**CHARTER TOWNSHIP OF VAN BUREN
PLANNING COMMISSION AGENDA
Wednesday, March 27, 2019 – 7:30 PM
Van Buren Township Hall
46425 Tyler Road**

ITEM # 4 CASE 19-009 – DTE ENERGY – SITE PLAN AMENDMENT

TITLE: THE APPLICANT, MATT VALASCHO IS REQUESTING AN AMENDMENT TO THE EXISTING SITE PLAN FOR DTE ENERGY TO PERFORM AN OUTDOOR LIGHTING

The following is a review of the proposed lighting improvements at the DTE property located at 8001 Haggerty Road. DTE Energy is proposed to install several light fixtures on their site for two (2) purposes: The first is that DTE is proposing to replace fixtures on their site for their general parking lot lighting. The second purpose is that DTE wants to provide several lighting options on the site to display to prospective municipal and other clients when they are searching for types of light fixtures to select when installing street and parking lot lighting. The plans are a bit difficult to navigate, so I want to provide a brief summary of how the plans are organized. The sheets which address the dawn to dusk master lighting plan and garage wall packs are for the general site lighting. These are the photometric plans for the lighting that will be on duri

DTE Outdoor Lighting Showcase & Proving Ground
Area Lighting Plan for Western Wayne Service Center (dusk to dawn master)
Community Lighting Group

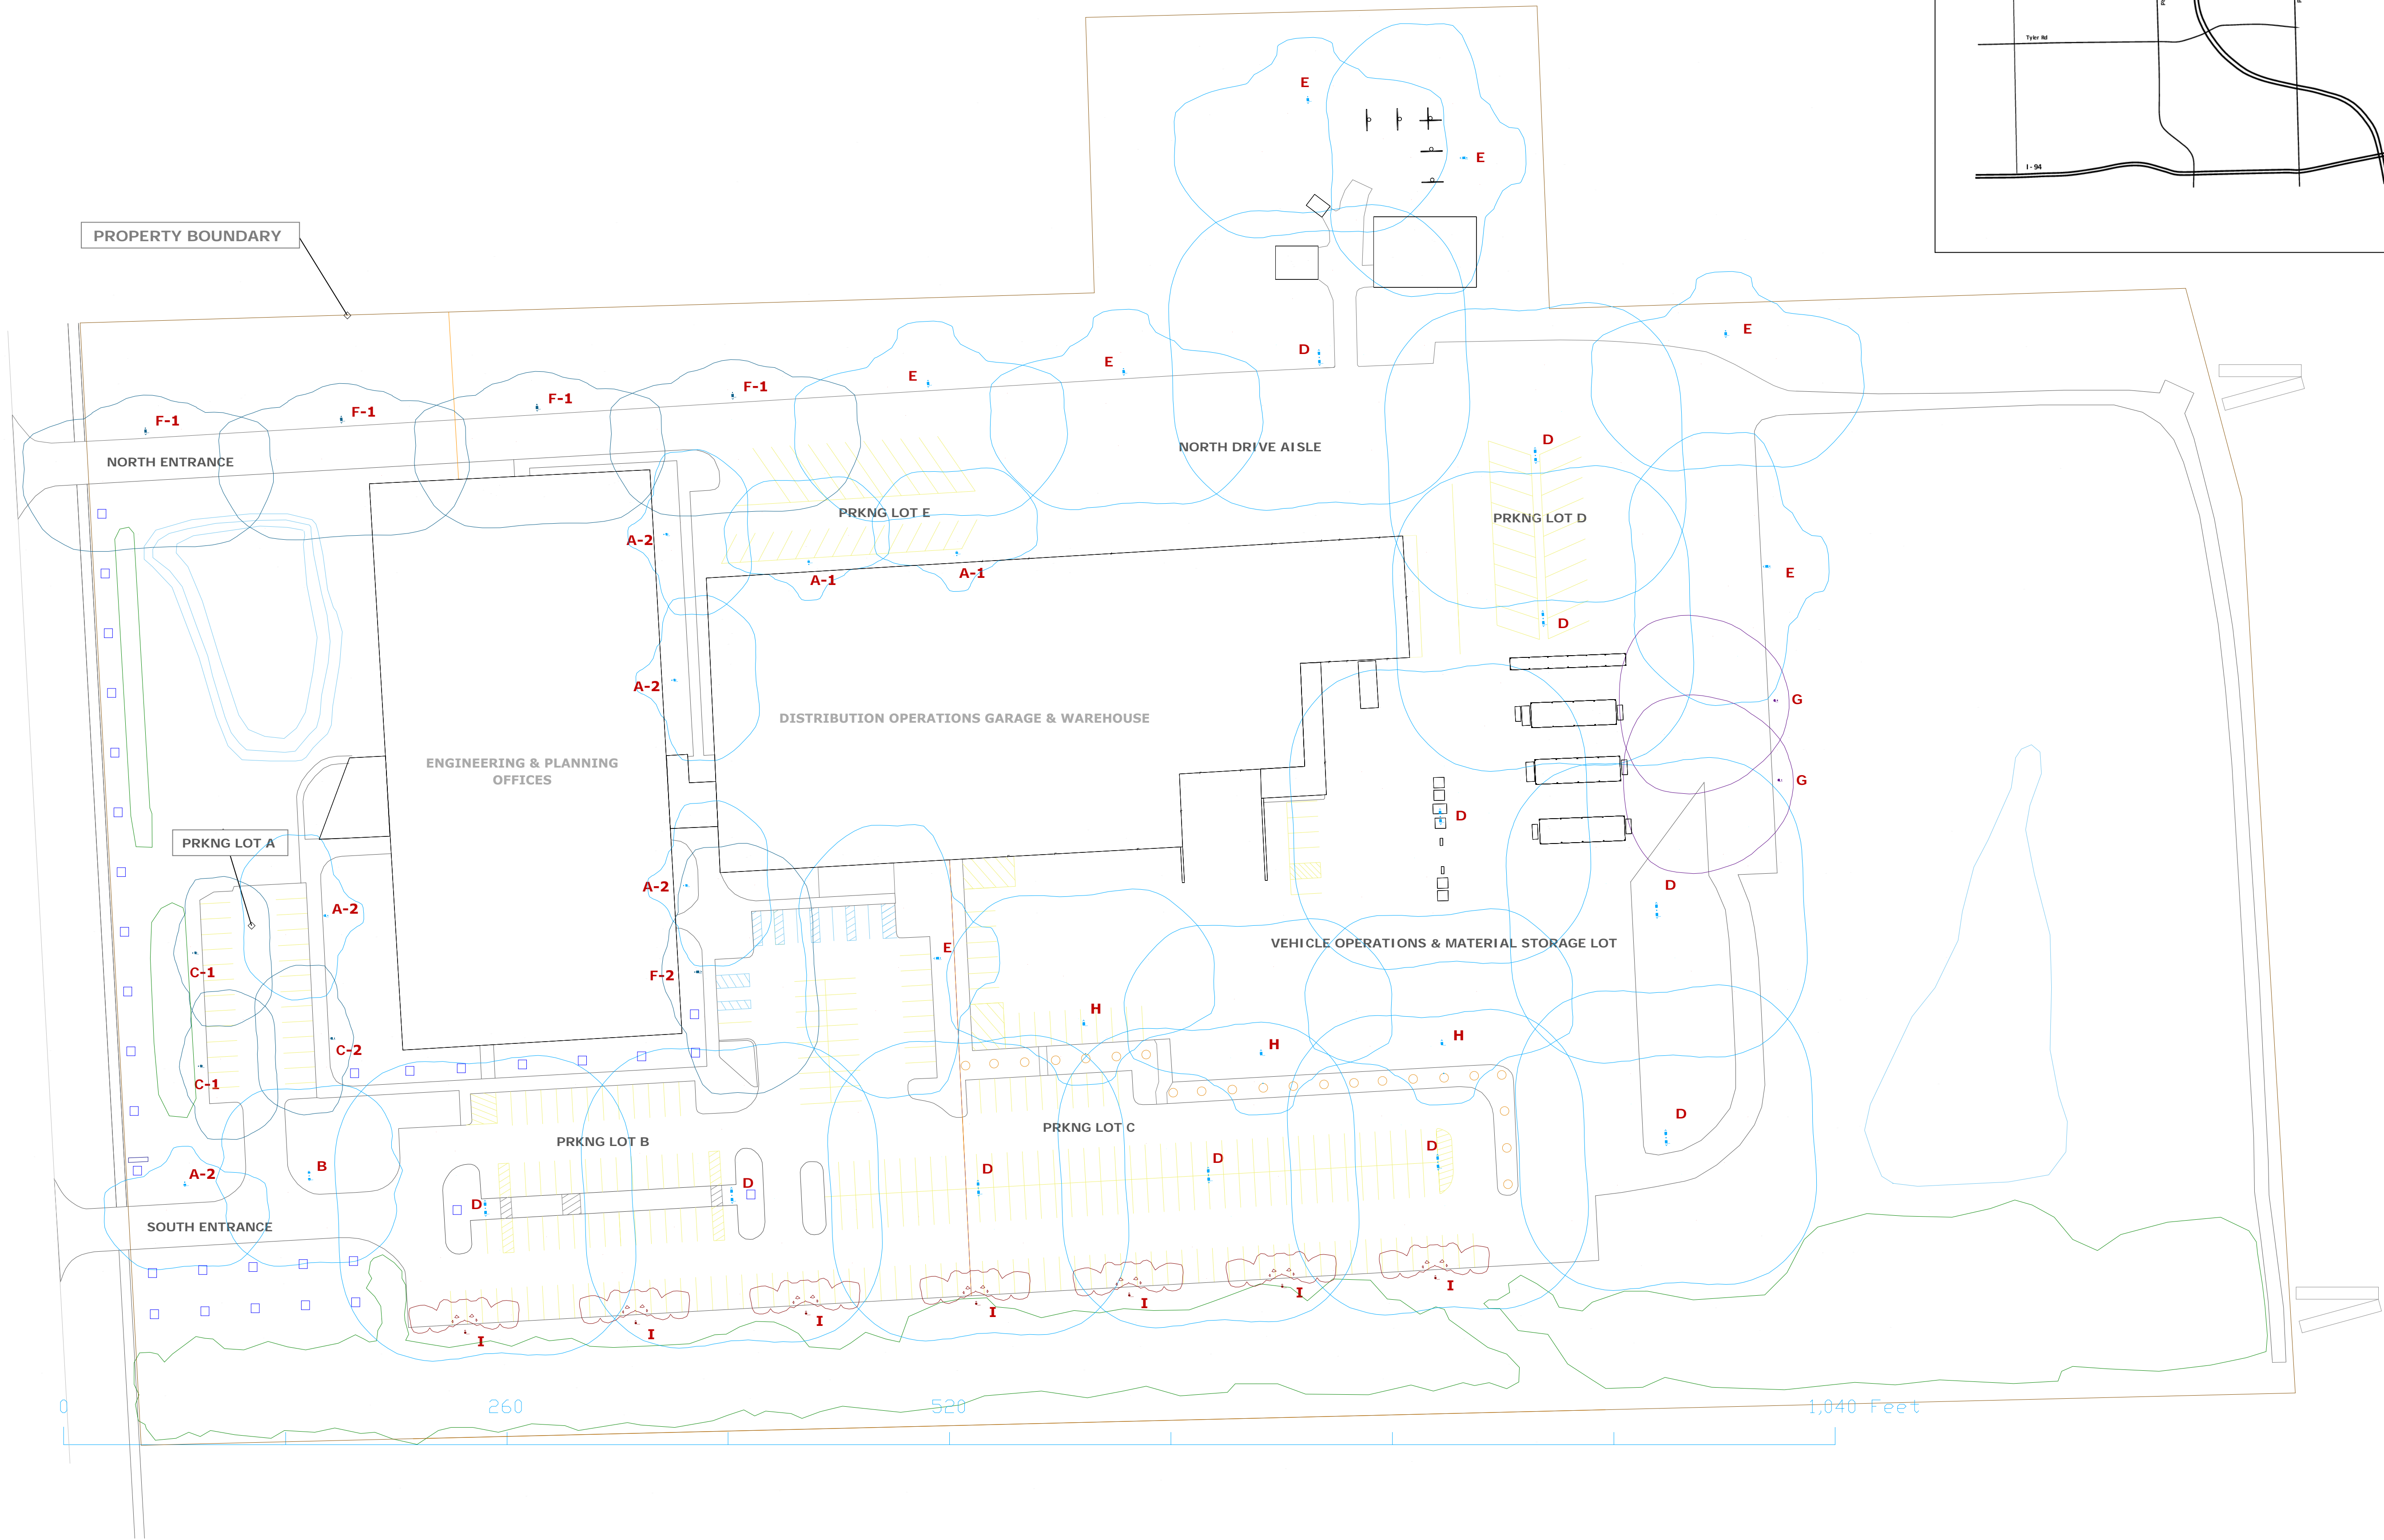
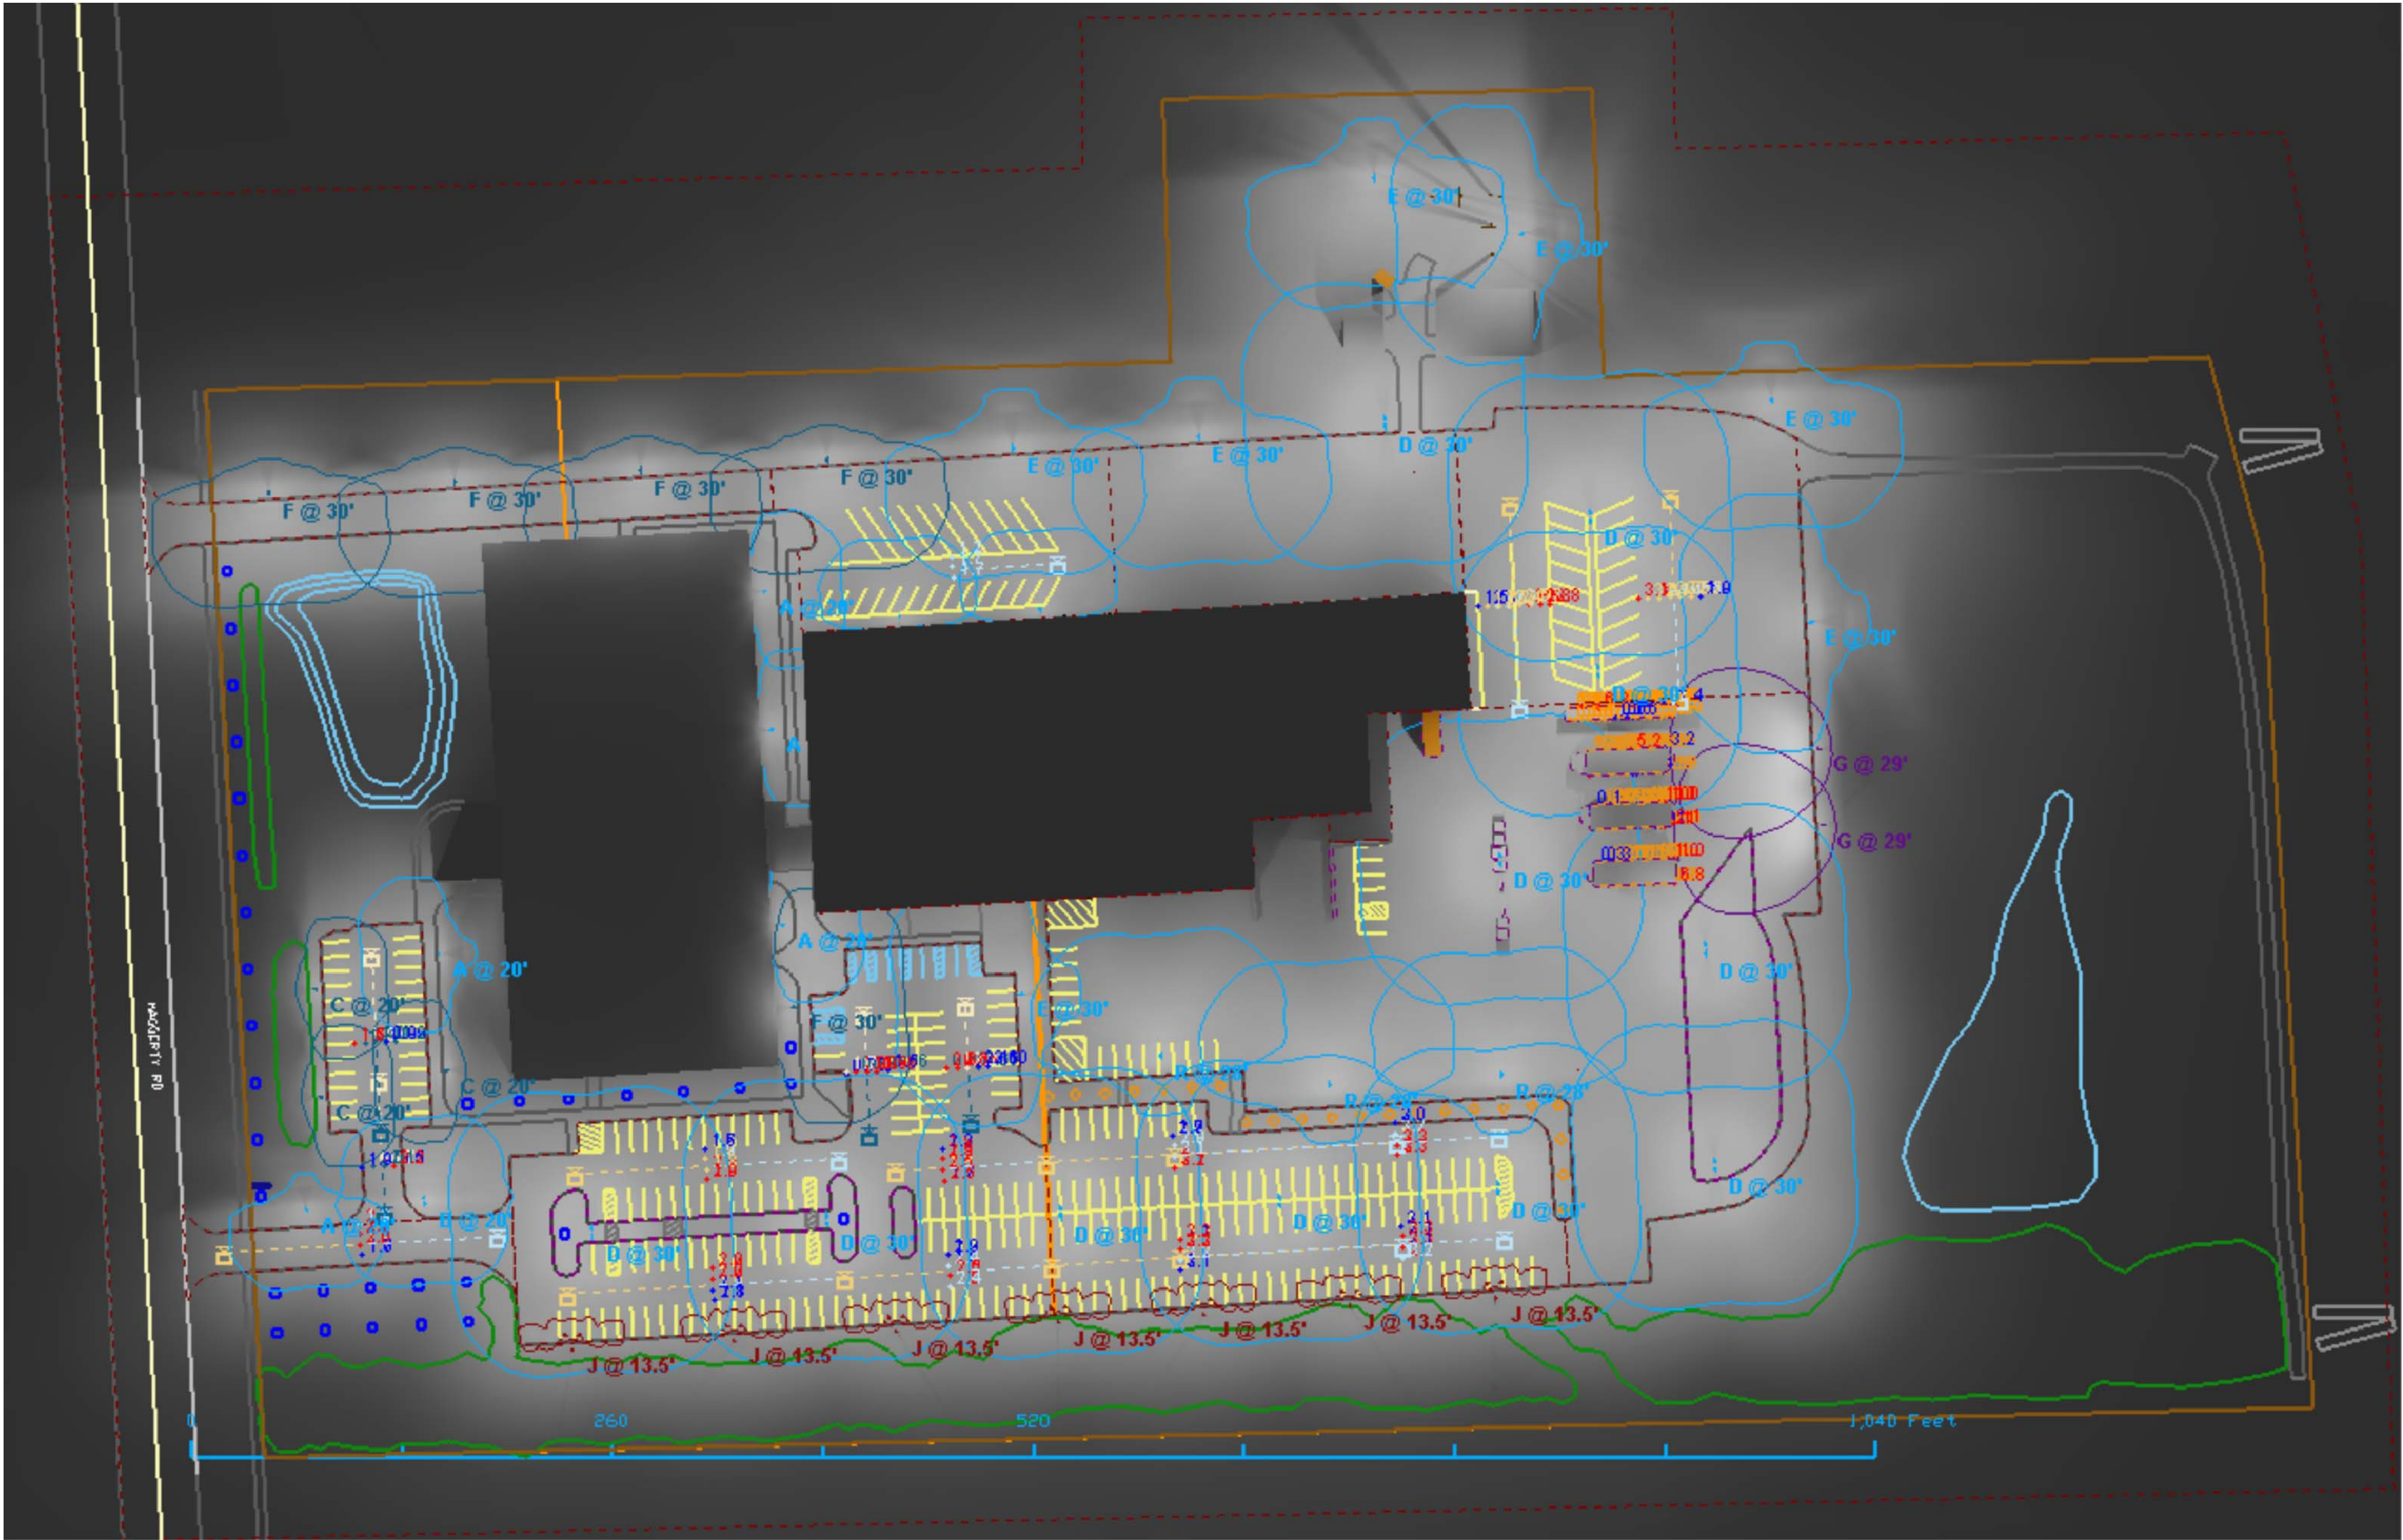
- a. **Light Trespass Limits:** Section 8.105(3) of the Zoning Ordinance requires that the light trespass from a property shall not exceed 0.5 foot candles at the property line. Upon review the proposed photometric plans it does not appear that the light trespass exceeds this. There is one portion of the plan where it appears the 0.5 contour line goes past the represented property line on the northeast portion of the site, but actually the area where the encroachment is demonstrated is a parcel which is also owned by DTE. Based on this there is no issue with light trespass.

- b. **Fixture Height:** The Township's Zoning Ordinance limits the height of light fixtures to 25', however the Zoning Ordinance does give the Planning Commission discretion to approve lighting fixtures in industrial districts of up to 35' so long as the proposed lighting has no adverse impacts on the surrounding land uses. The maximum proposed fixture height for the general area lighting poles and the display poles is 30' tall. The surrounding land uses are industrial to the south and west, freeway to the east and there is a home/business to the north of the

property. Based on the photometric plan, it does not appear that this fixture would have an adverse impact on any of these properties. Staff recommends that the Planning Commission grant the applicant the ability to install light fixtures up to 30' tall.

- c. **Shielding:** Section 8.105(b)(1) of the Zoning Ordinance requires that outdoor lighting be shielded so that all outdoor lighting shall be directed toward and confined to the ground area. This section also requires that owners use full cut-off fixtures to prevent light from projecting above a 90 degree horizontal plane. The following diagram is listed in the Zoning Ordinance:

2. The Planning Commission allows the applicant to install light fixtures up to 30' as proposed in the submitted plans.
